Planning and Development Council Meeting  
March 18, 2019

**Comments Received Regarding Item 2**  
Zoning By-law Amendment and Draft Plan of Subdivision  
47 Nelson Street  
File NO. Z.1728.65 and 24T-18007/1728

# Summary of Concerns with Respect to the Proposed Development at 47 Nelson St.

SHADE PLAN - 2328 MARINE DRIVE

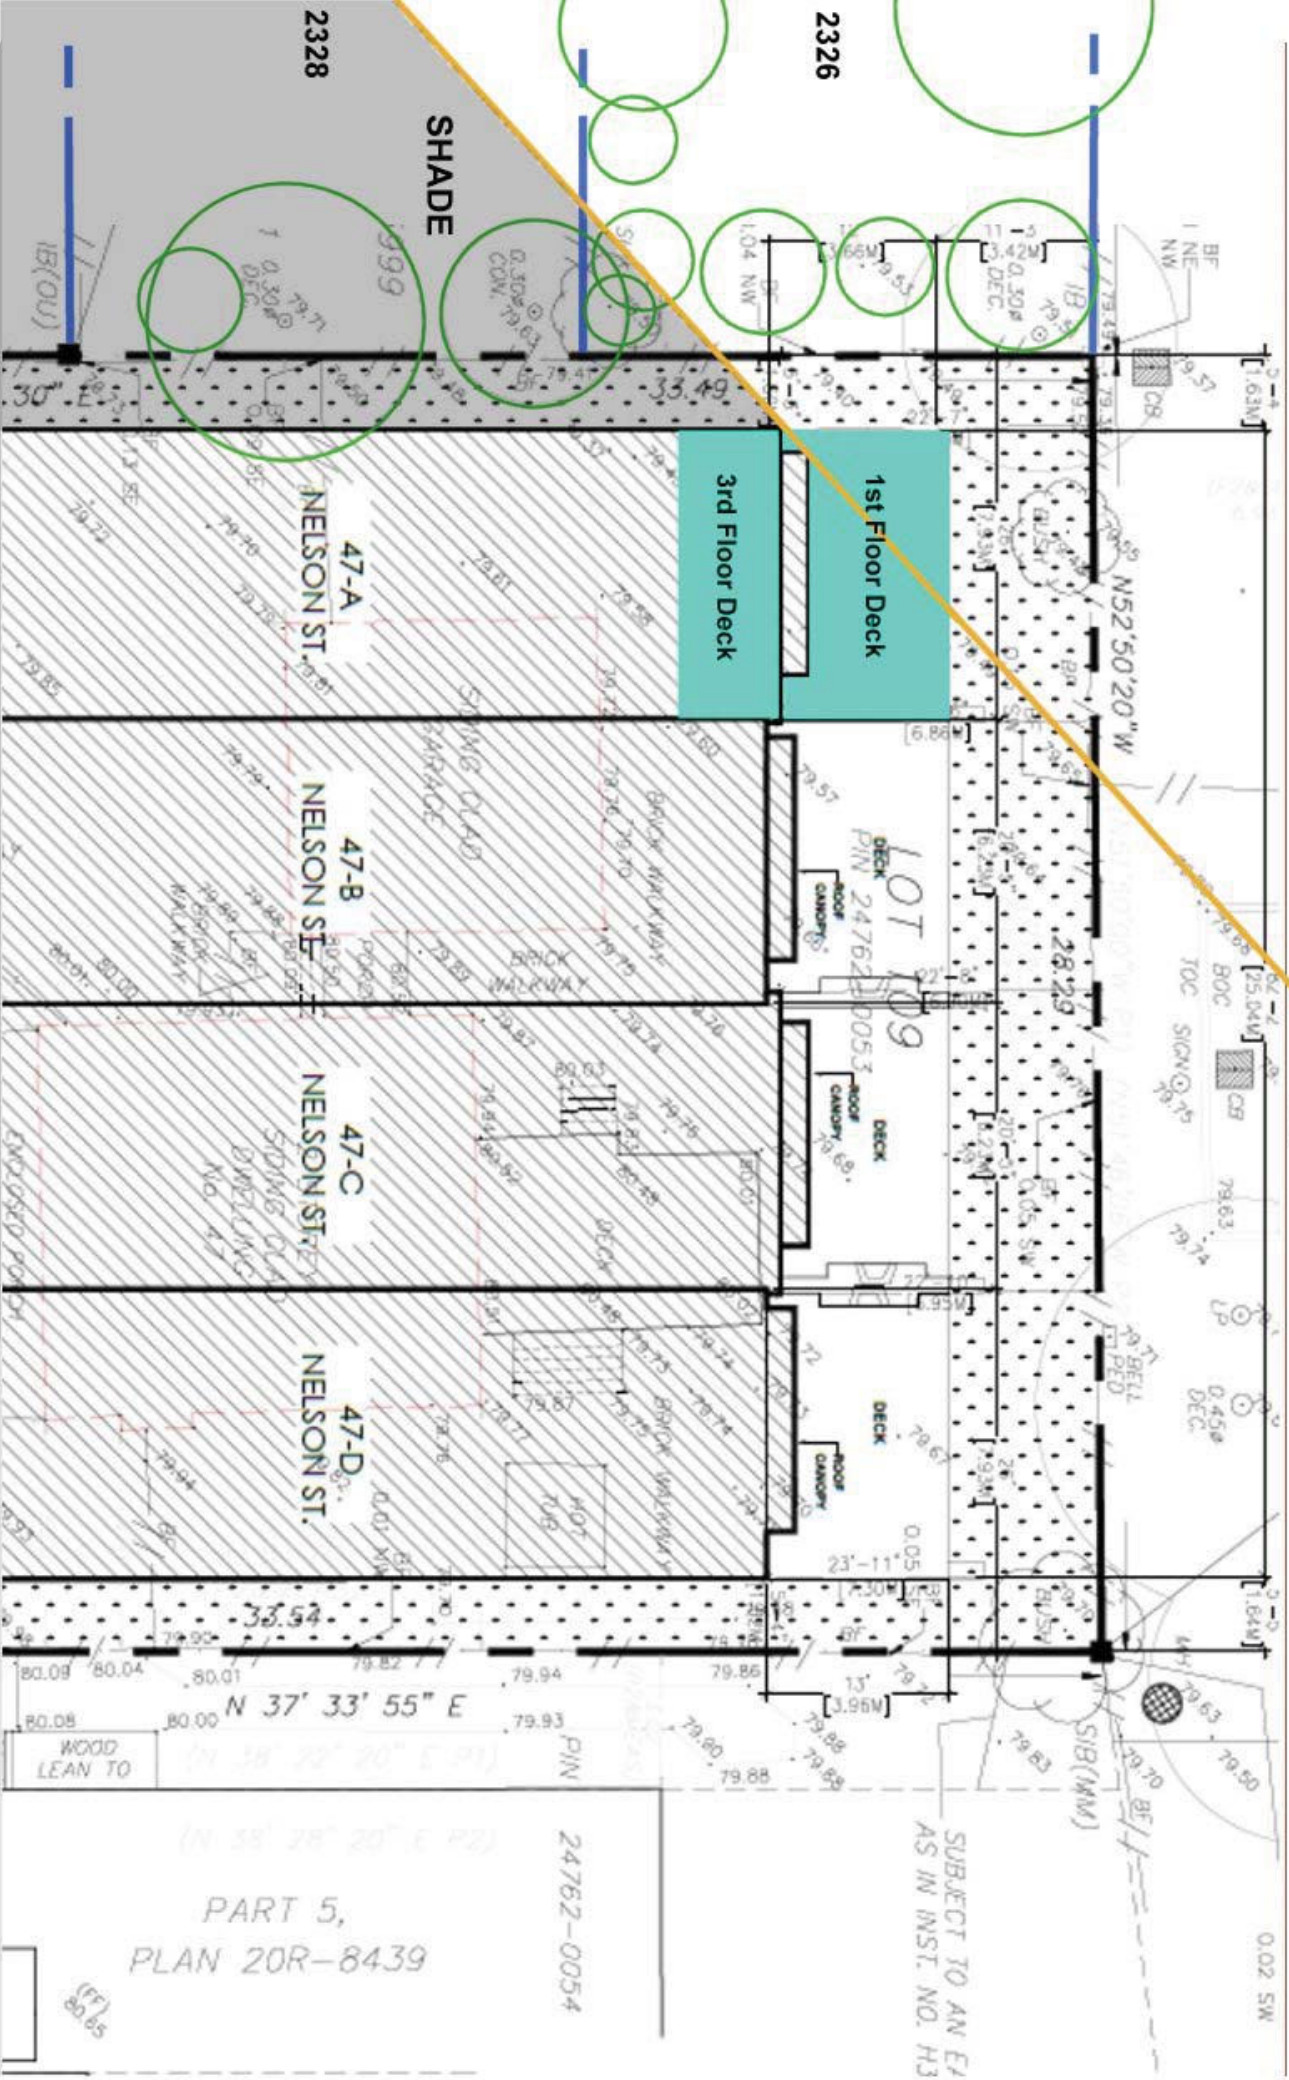
Please find attached an updated diagram of the impact of the proposed TH development on the sunlines in my backyard. My backyard is currently a wonderful sun pit. The height of this development and its proximity to my lot line, if permitted to proceed, will permanently occlude the sun from the greater part of my backyard. I request that serious consideration be given to reducing the height of this development to two storeys....please.

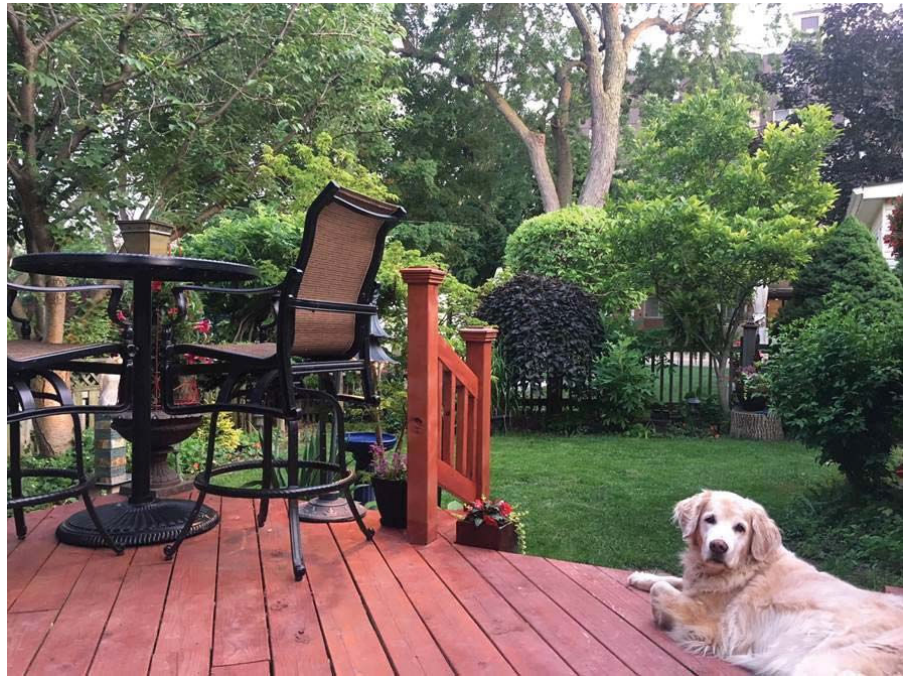
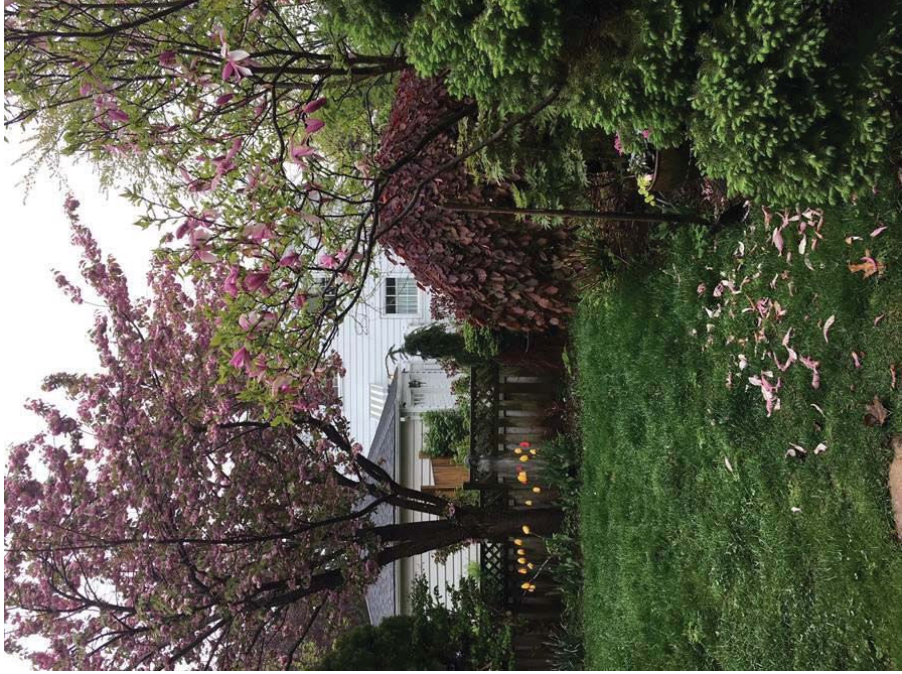
Please see attached photos to accompany my submission for the above proposal, illustrating the view that would be lost, as well as the mature trees that would be threatened in my yard.  
Thank you for your review of this submission.  
Regards,  
Diane Garley  
[REDACTED] Marine Drive

MORNING SUN SHADOW LINE

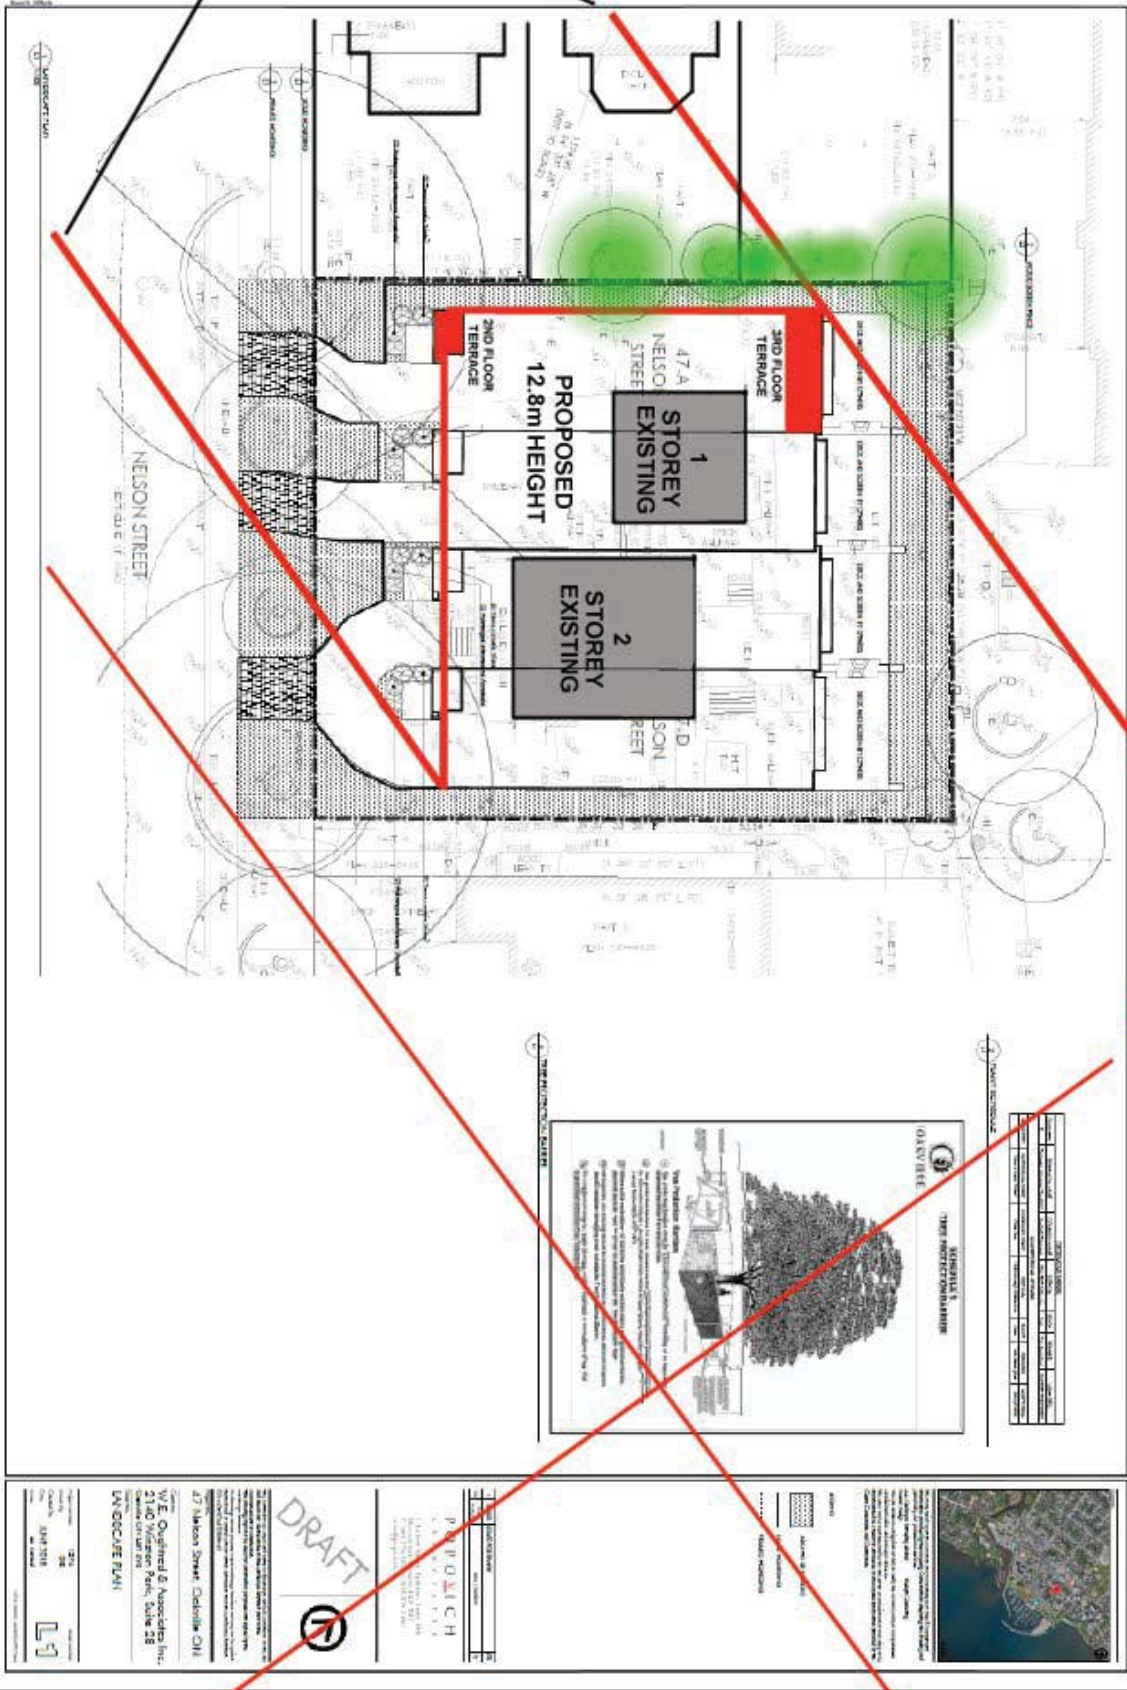
My second concern is of a more personal two-fold nature. Simply put, and without meaning to sound selfish, I stand to lose the most, should this townhouse development go forward. As the middle of the 3 homes that back on to 47 Nelson Street, and because the proposed development would be erected just 1.6 metres from my bottom property line, and extend the entire width of my backyard, I will be looking out at a high solid wall, that will significantly impact the light in my yard. This has the potential to have a devastating effect on my mature trees, two of which have been identified in the arborist report, as needing protection. I am not reassured that 1.6 metres is anywhere near sufficient to protect the roots of these large trees. As you know, the current owners of 47 Nelson Street have applied for a variance, that would permit the height of the development to exceed RM1 requirements by .8 metres. Given the proximity to my lot line, this variance is very significant, and completely unacceptable. It would even further block the sunlight in my yard, and over time, is sure to have a deleterious effect on the growth of my trees. To illustrate my point, I am submitting a shadow diagram, which clearly shows the negative impact, if the variance applied for, beyond the RM1 height allowance was to be approved.
